## **Technical Service Bulletin**

GROUP	NUMBER
FUEL SYSTEM	18-FL-002
DATE	MODEL
JUNE, 2018	ACCENT (RB)

SUBJECT: CCV AND AIR DRAIN CASE INSPECTION/REPLACEMENT

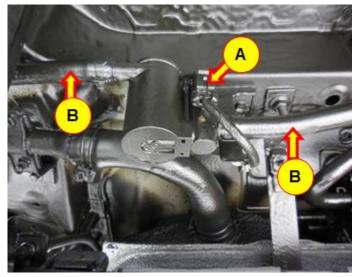
PART NAME	FIGURE / PA	QTY.		
FAIT NAIVIL	PREVIOUS	NEW	Q11.	
CCV	Port color : Black 31453-3K600	Port color : Ivory 31453-3K600FFF	1 each (when applicable)	
Air Drain Case	31035-2K500	31035-B2500FFF	1 each
